PPSSSH-70 - 5 to 9 Ozone Street, Cronulla

MA21/0080

ASSESSMENT REPORT APPENDICES

MODIFIED DEVELOPMENT APPLICATION NO. 21/0080

JOINS L-1003

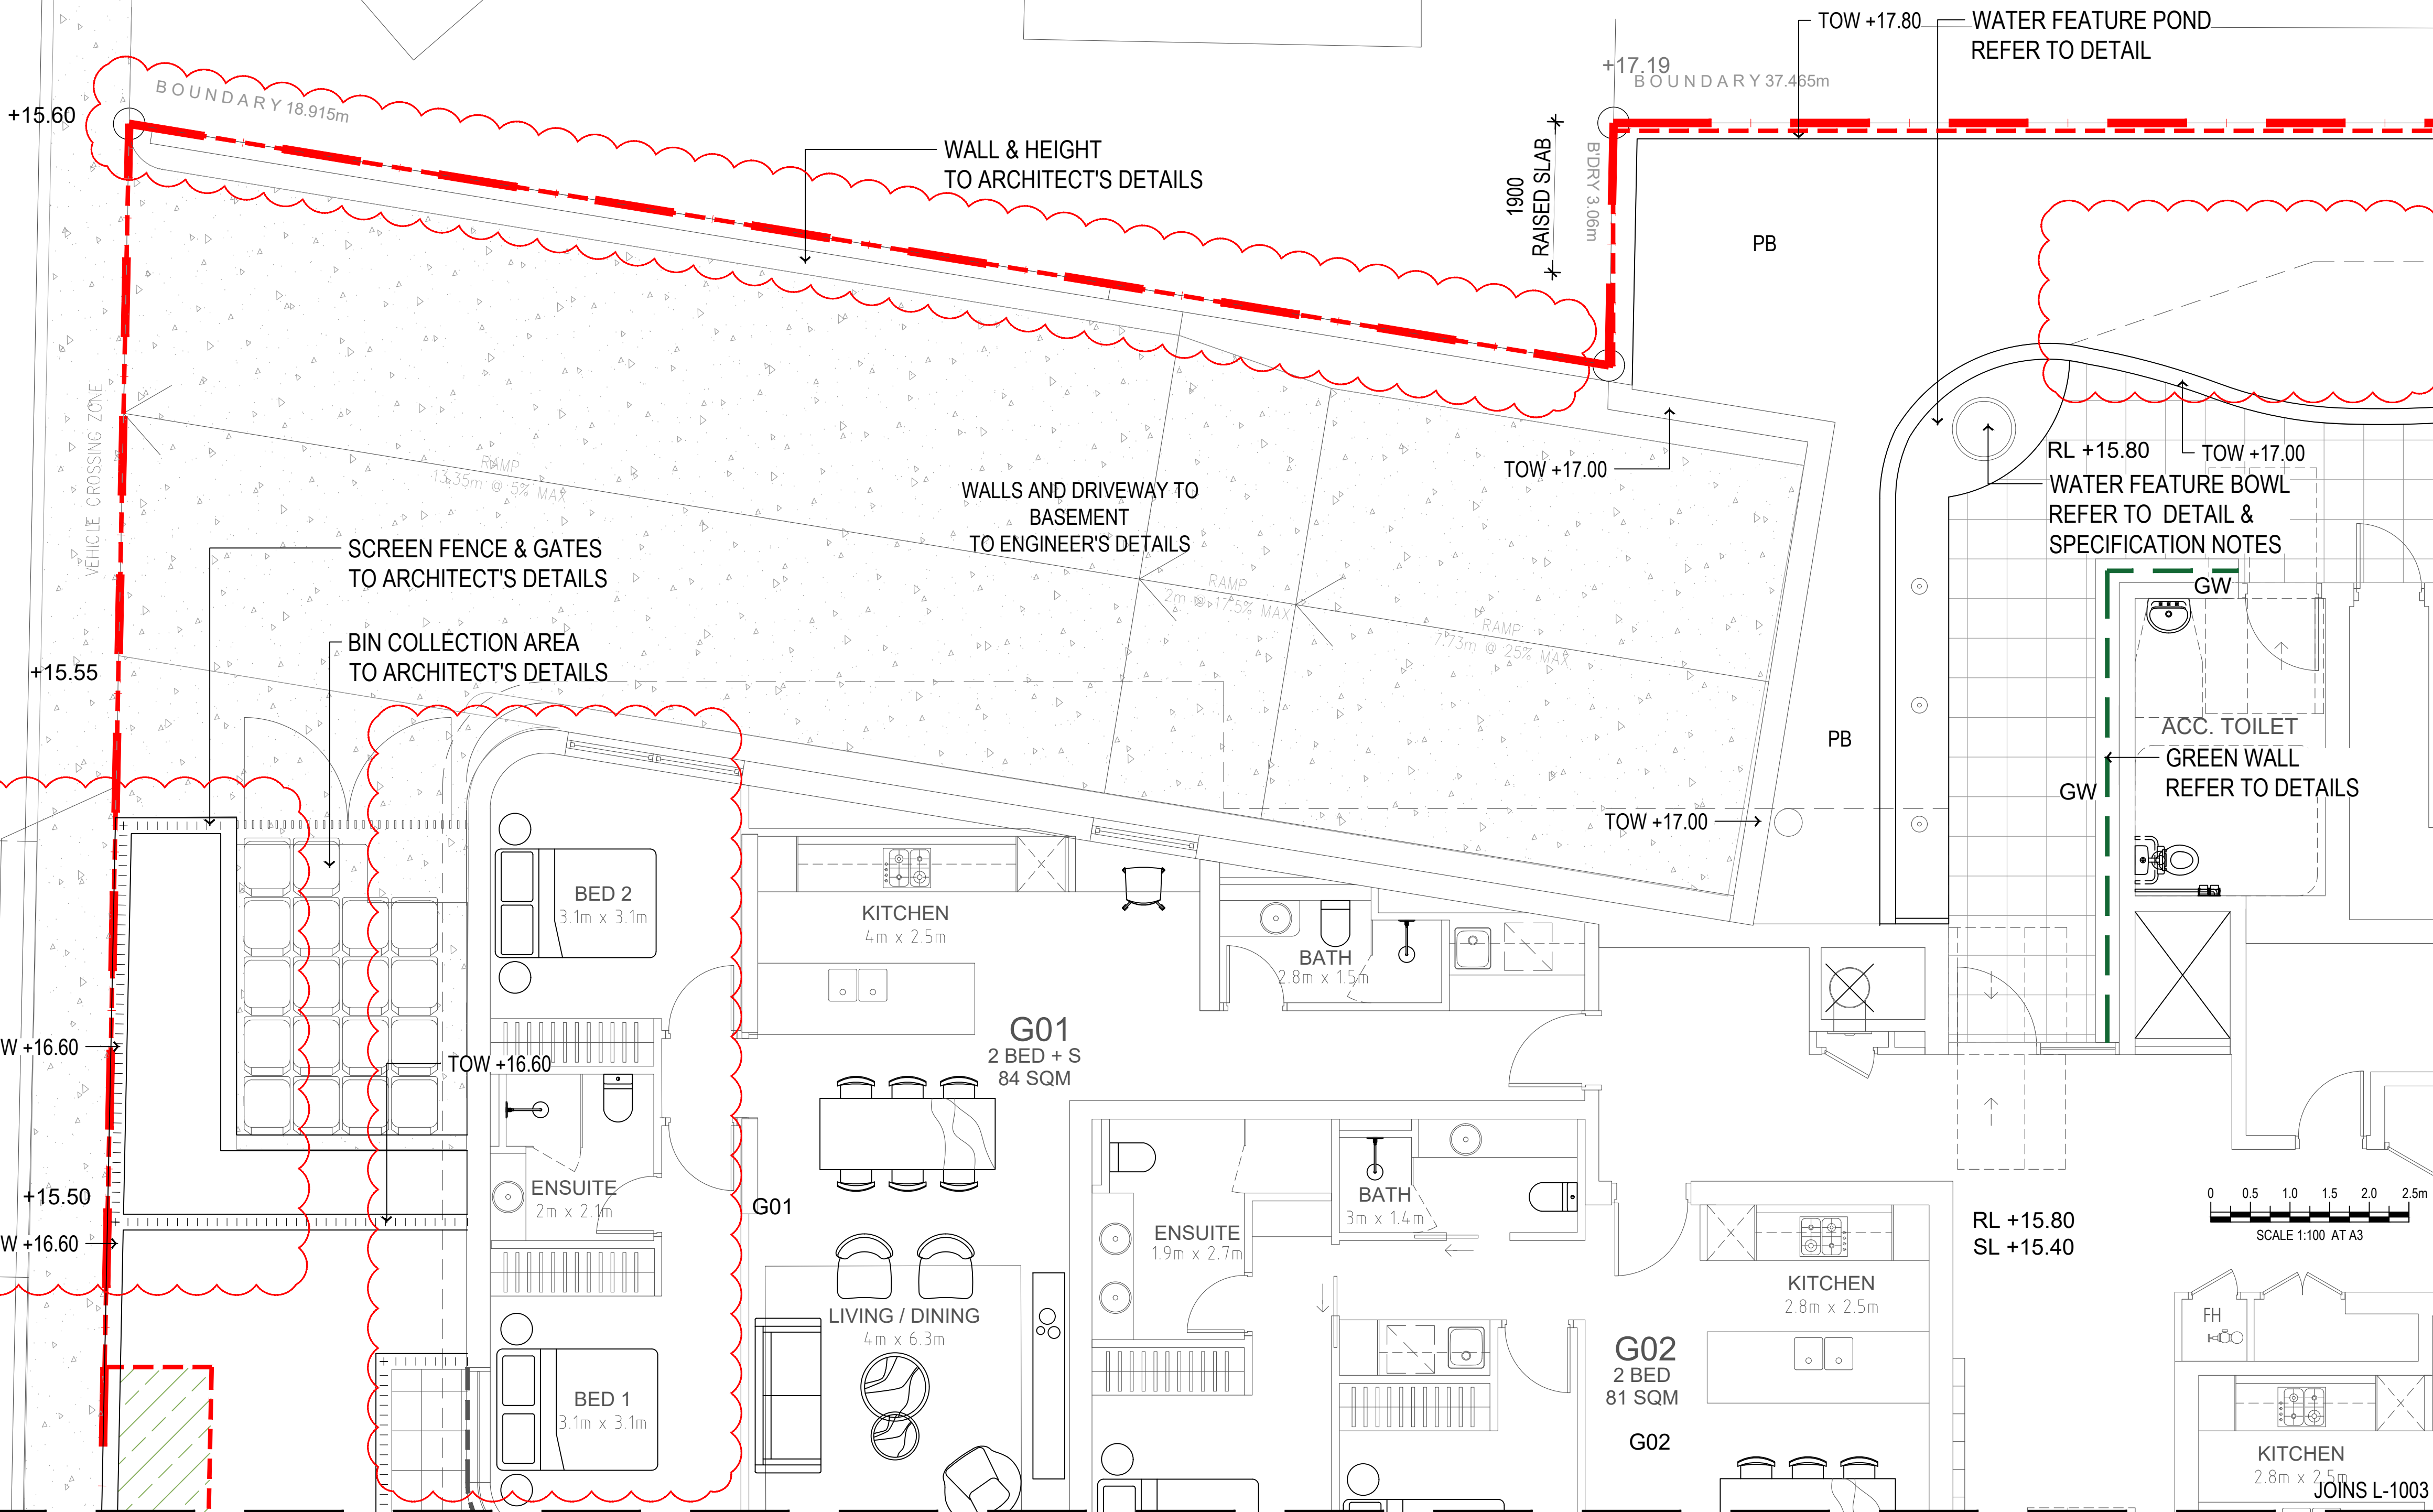
- xvii) The palisade fence (shown on L-1001/D Landscape Layout Plan01, Habit8 dated 2 February 2021) is to be installed on the wall that encloses the concreted bin collection area only.

- v) The palisade fence (shown on L-1001/D Landscape Layout Plan01, Habit8 dated 2 February 2021) is to be installed on the wall that encloses the concreted bin collection area only and not exceed 1.5m in height.

DRAWN	CHECKED	
KM	DV	
PROJECT NO.	DRAWING NO.	REVISION
H8-20030	L-1003	D

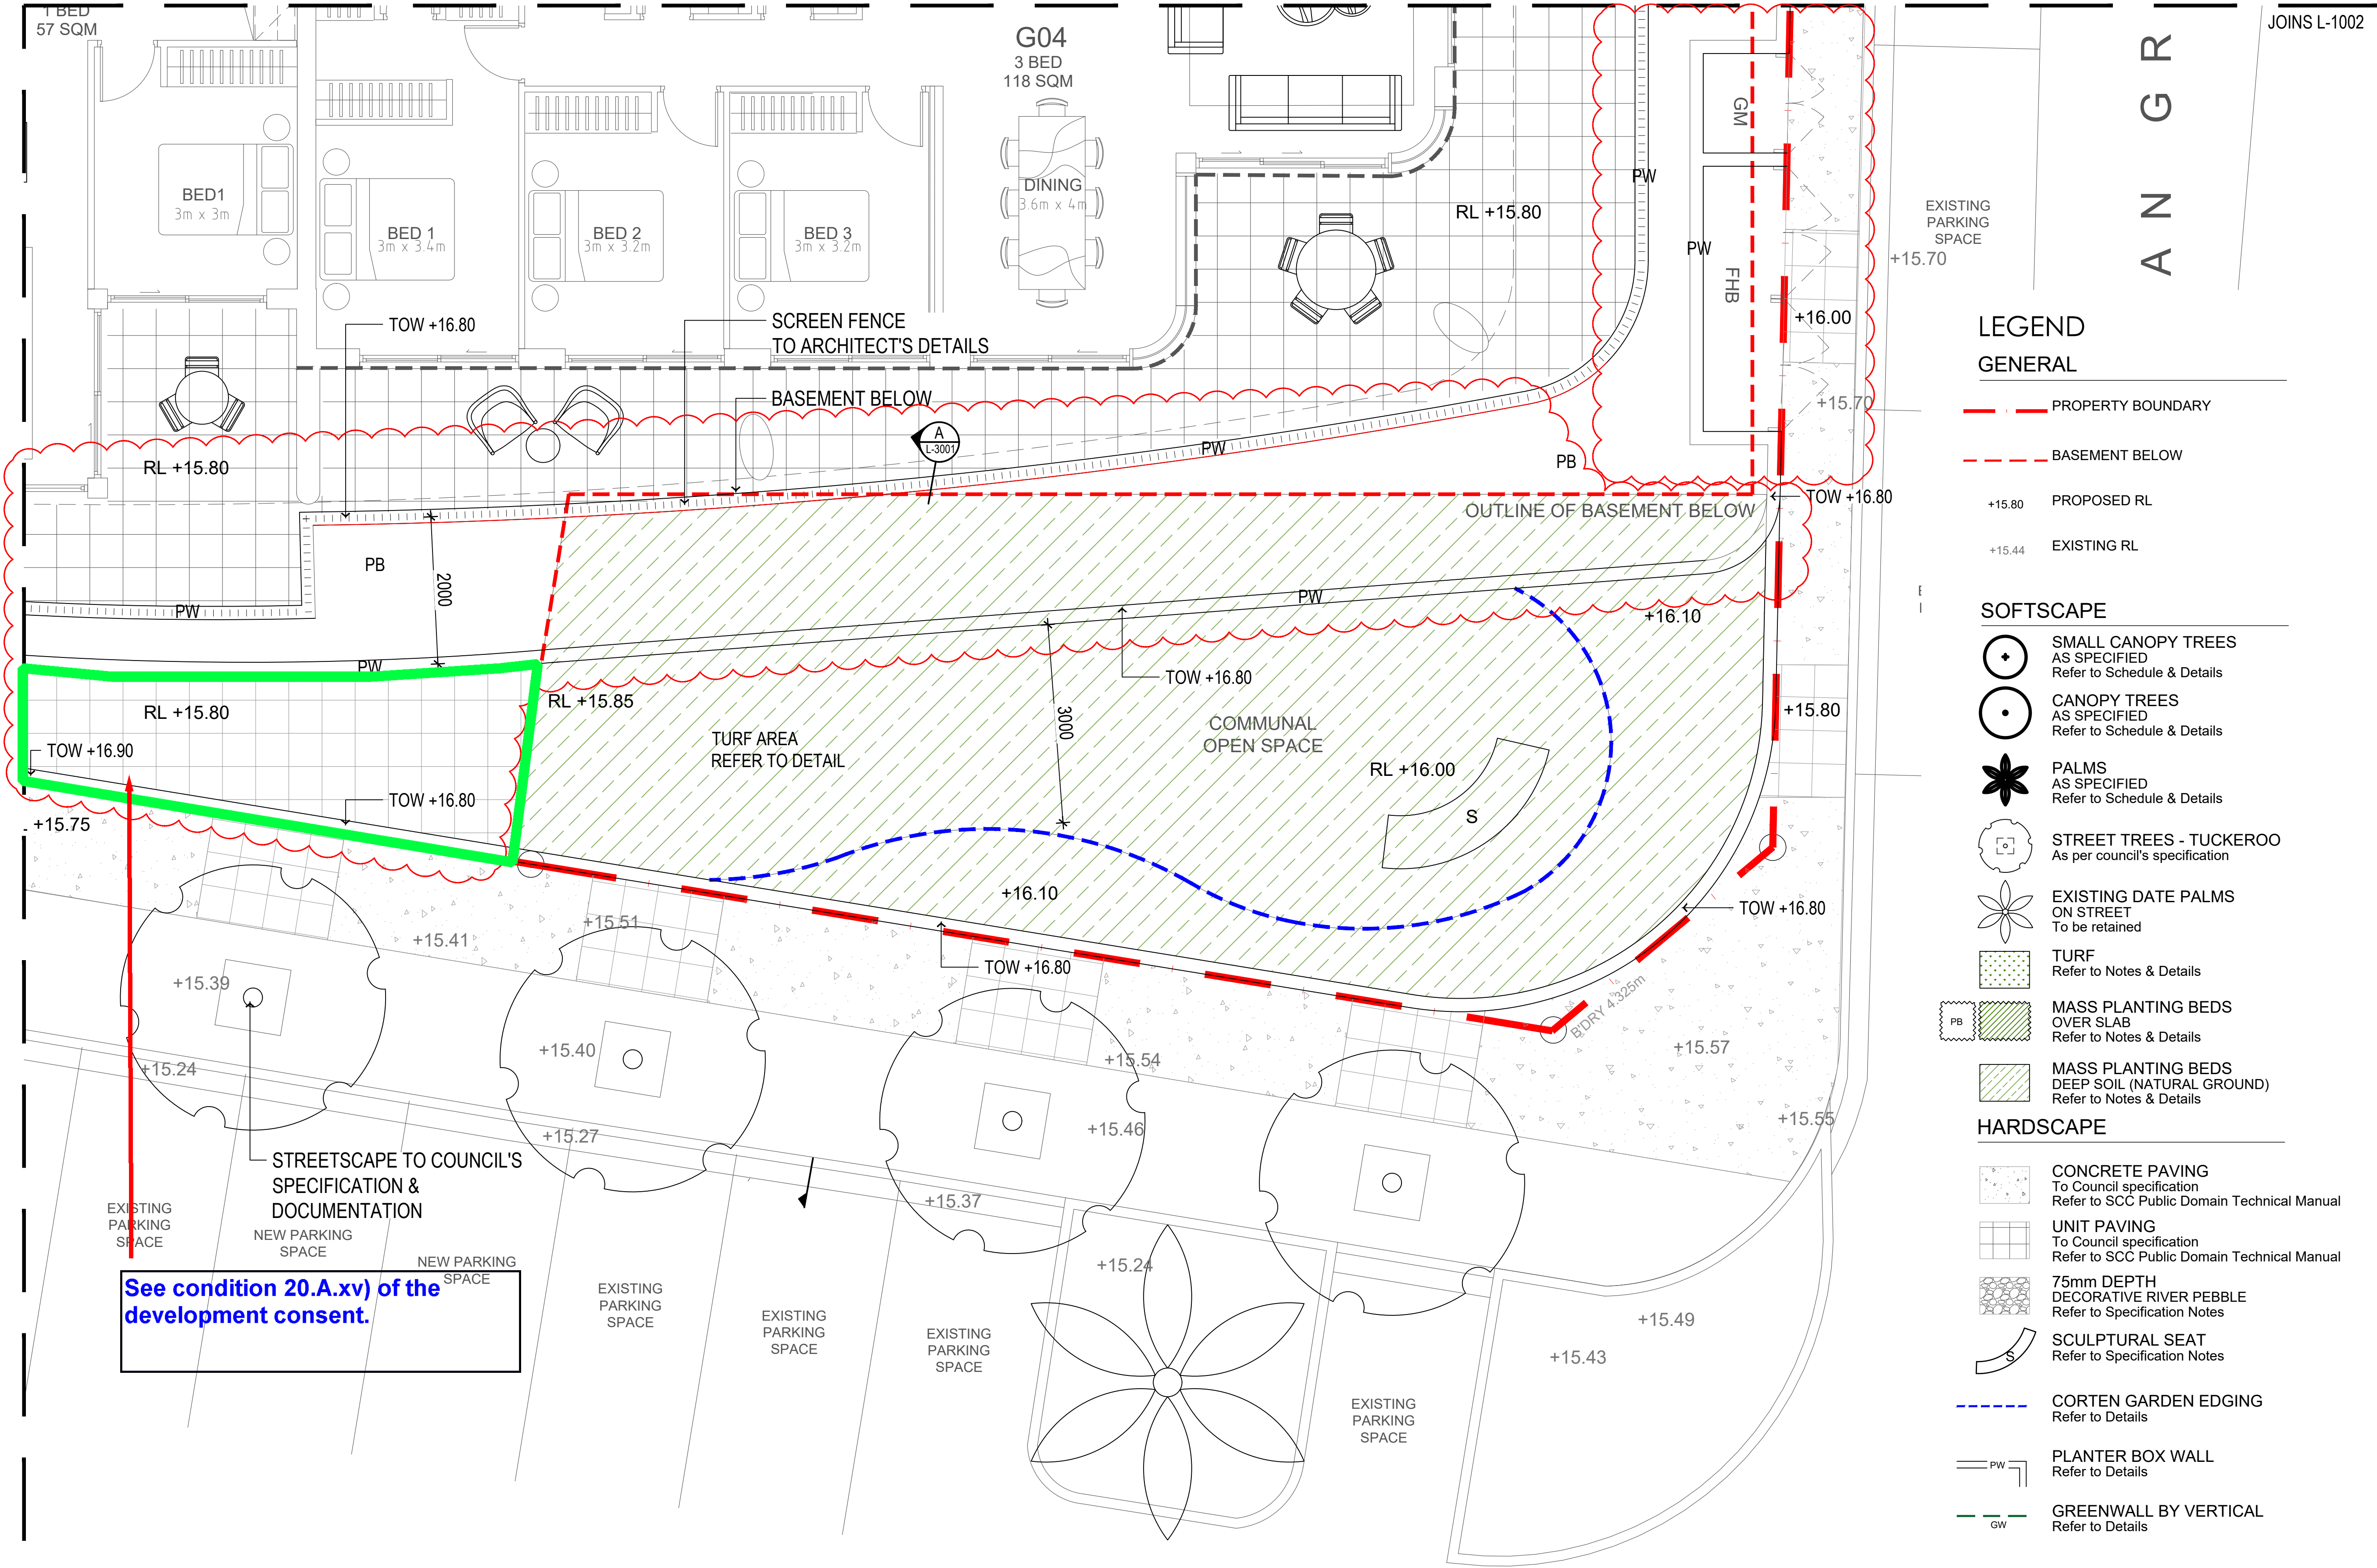
- xiv) The paved entry area in front of unit G03 providing access to the front north eastern communal space (shown on L-0003/D, Landscape Layout Plan 03 and L-0004/D, Landscape Layout Plan 04, by Habit8, dated 2 February 2021) is to be converted to garden and planted. The planting bed and turf is to continue from the communal open space to the front pathway into entrance of the building.

PROJECT NO.	DRAWING NO.	REVISION
18-20030	L-2003	D

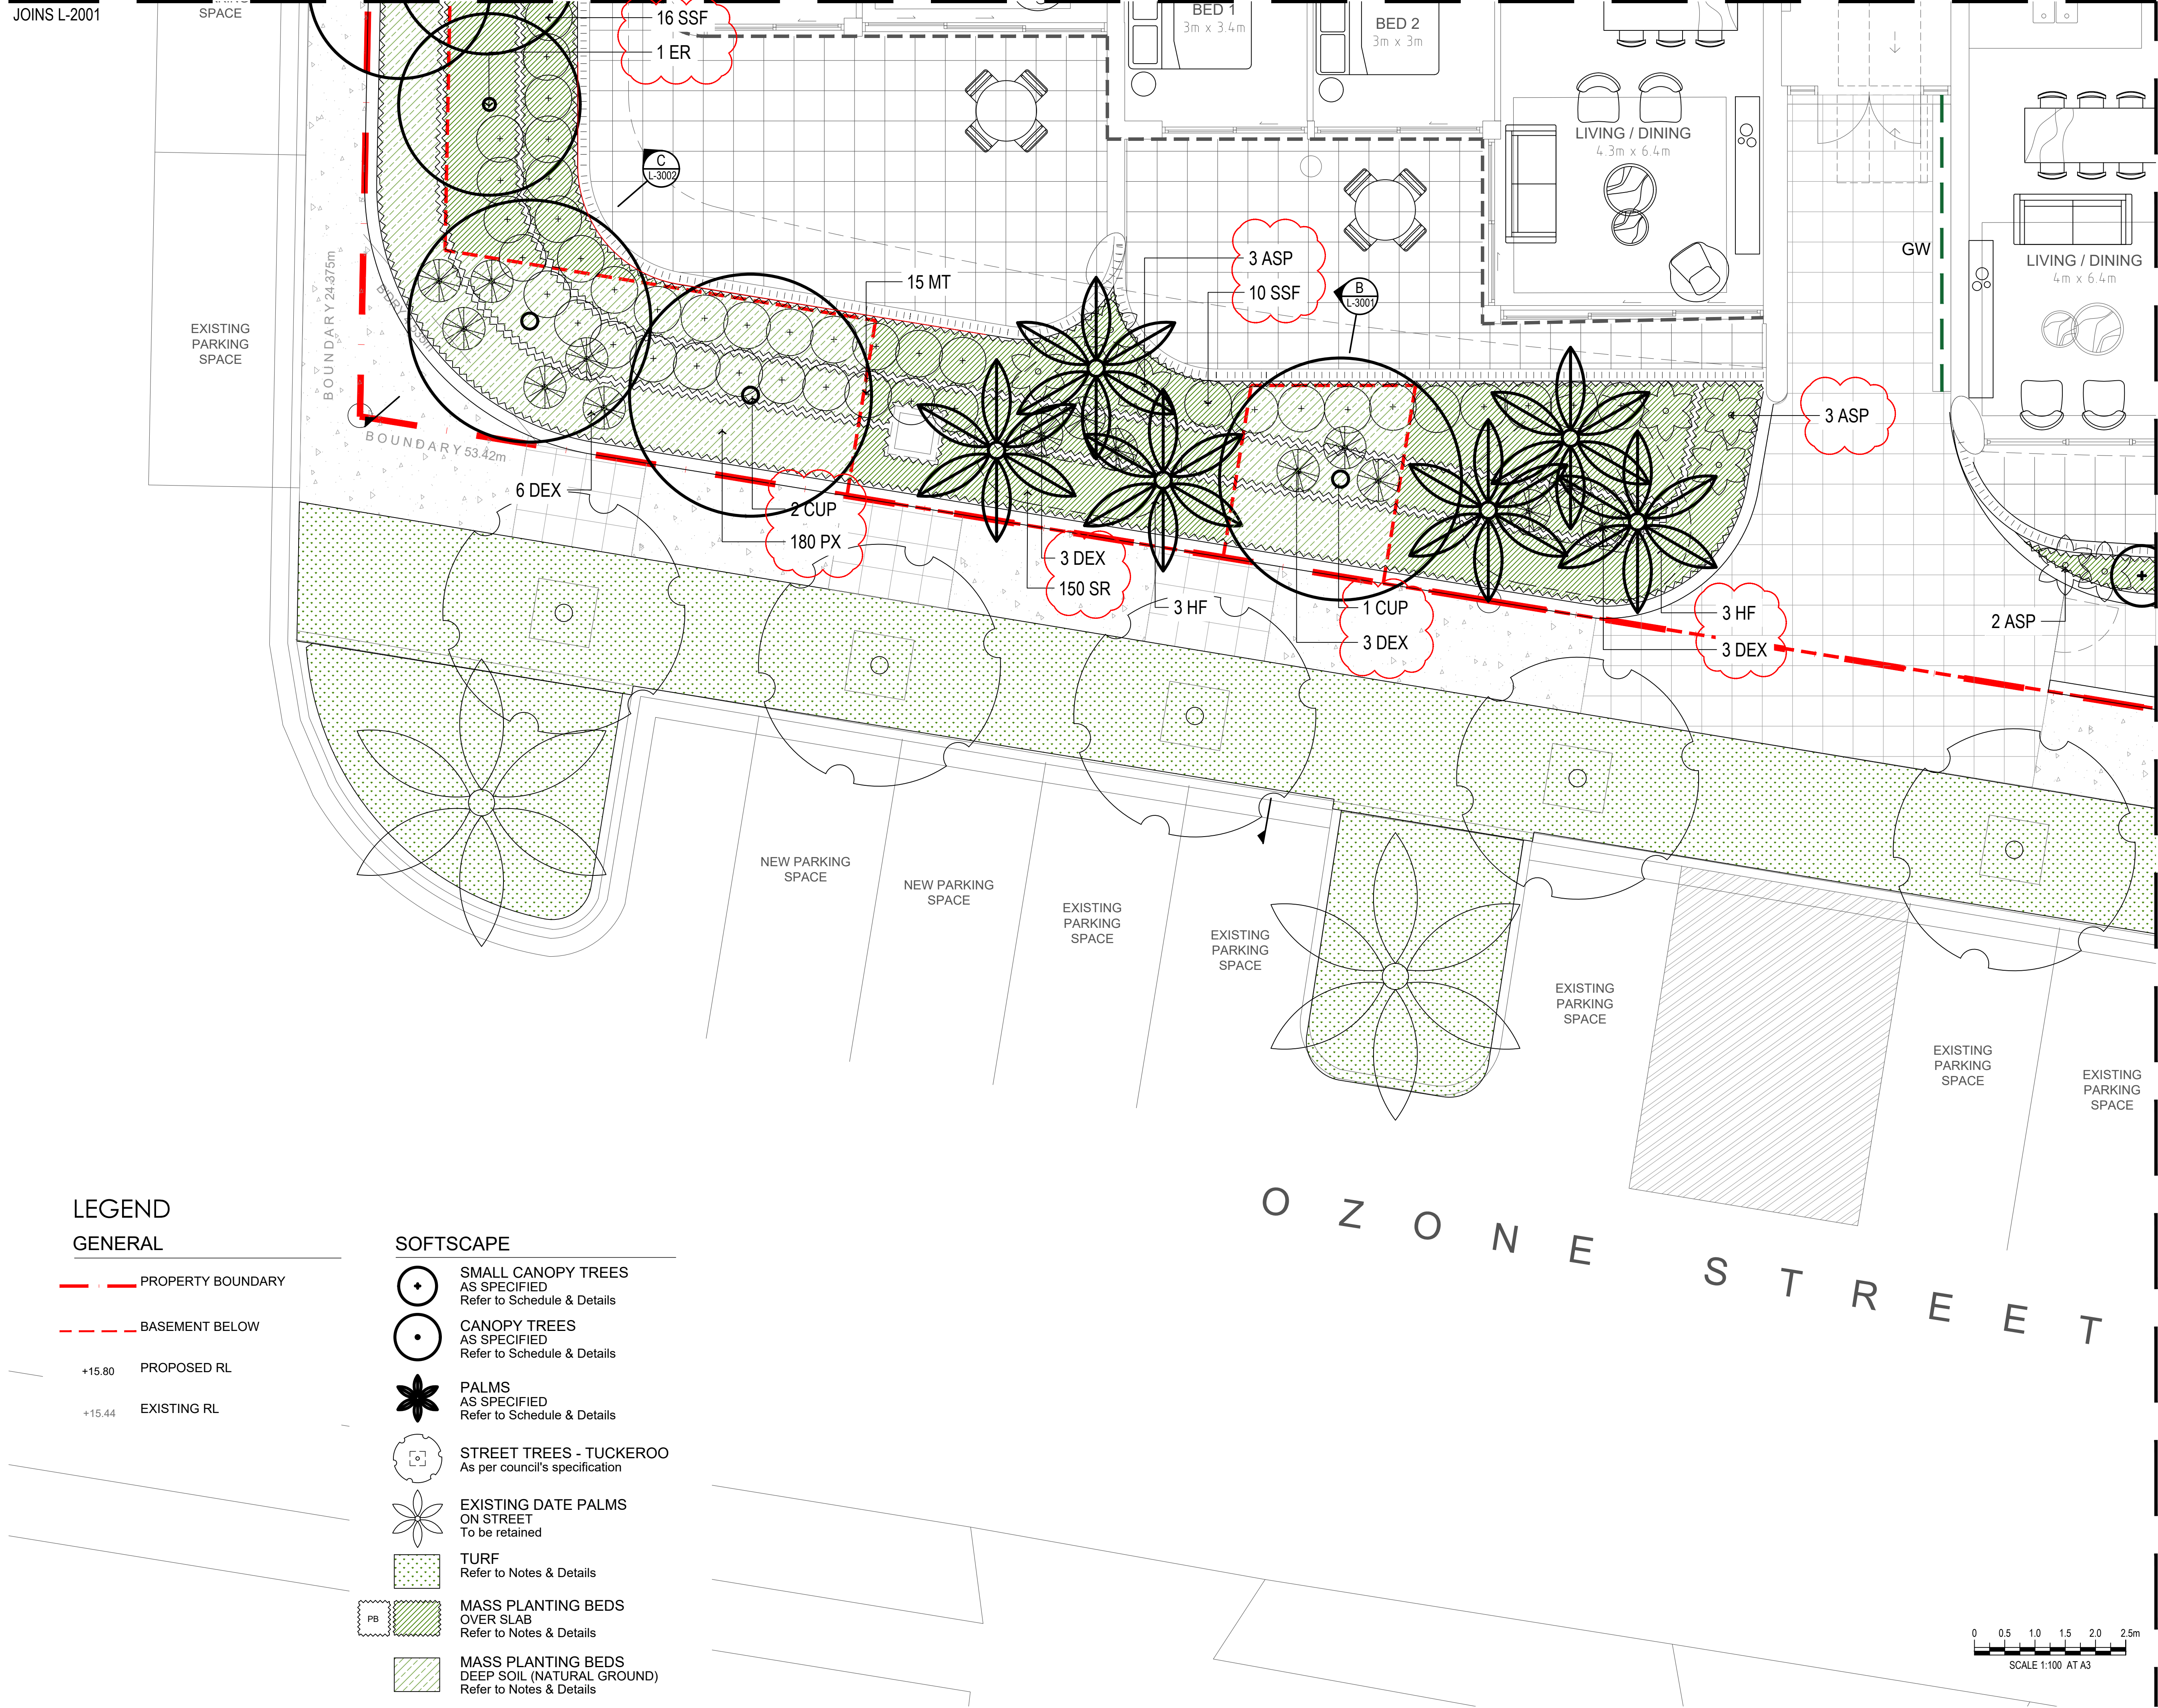
- xv) The total number of shrubs to be planted along the three frontages of the site (as shown on L-2001/D Planting Plan 01, L-2002/D Planting Plan 02, L-2003/D Planting Plan 03, L-2004/D Planting Plan 04, Habit8, dated 2 February 2021) are to be increased in numbers to 385 shrubs.
